Technical Service Information

FORD A4LD TIE-UP IN THE PARK POSITION

Figure 1

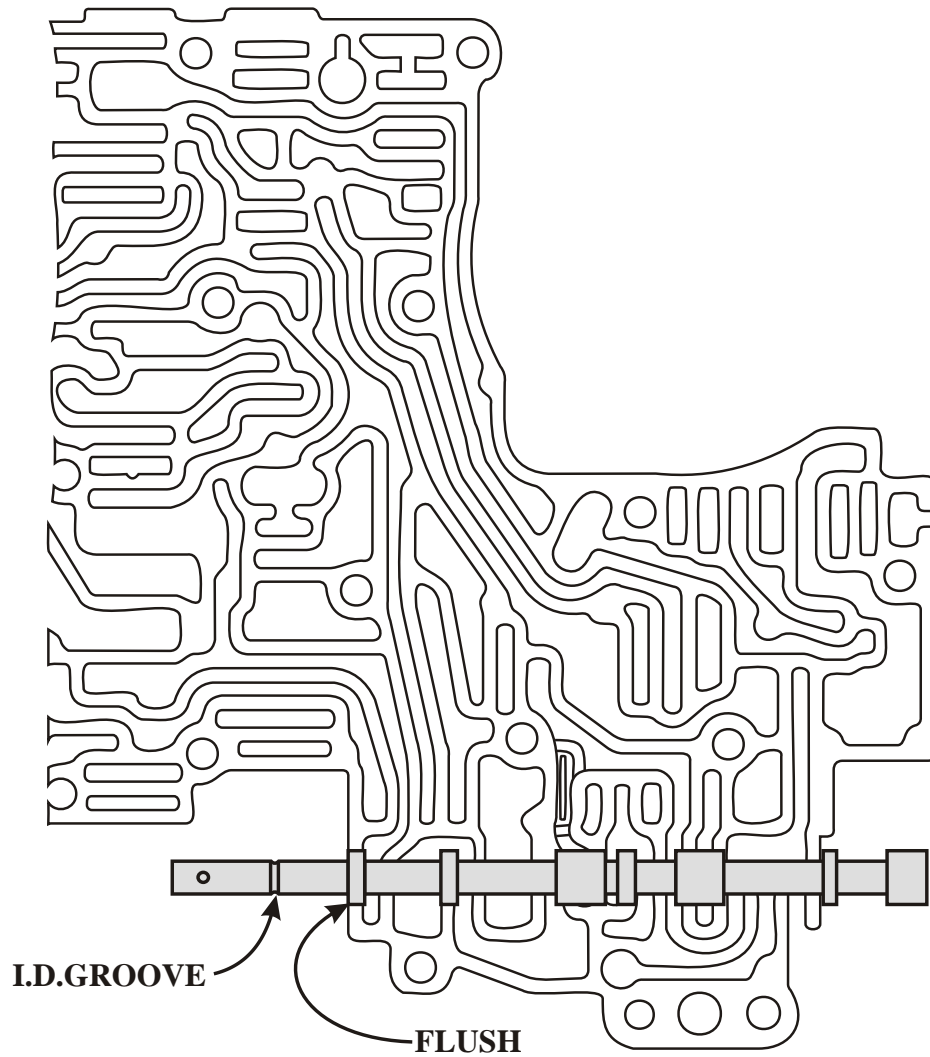
COMPLAINT: After overhaul, your A4LD transmission exhibits a "Tie-Up" condition, when the selector lever is placed into the Park position.

CAUSE: The cause may be, an improperly adjusted manual valve. The .075" puck supplied in some gasket sets and in some valve body kits WILL NOT WORK ON ALL MODELS. On SOME valve bodies, using the "Puck" to adjust the manual valve, will allow the manual valve to move past the Park position and apply the forward clutch.

1. Measure the link hole in the manual valve to ensure that it is .157" in diameter, and has not elongated due to wear. It is also recommended to use the latest manual valve, with the I.D. Groove near the link hole, and available under OEM number E8TZ-7C389-A. (See Figure 1).
2. With the valve body installed on the transmission, place the manual lever into the "D2" position.
3. With the manual lever in the "D2" position, the first land on the manual valve should be flush with the valve body casting, as shown in Figure 1. However, approximately .010" below flush to .020" above flush with the valve body casting is totally acceptable.
4. Bend the manual valve link as necessary to achieve the dimensions listed above.

WITH THE MANUAL LEVER IN THE “D2” POSITION THE FIRST LAND ON THE MANUAL VALVE SHOULD BE FLUSH WITH THE VALVE BODY CASTING
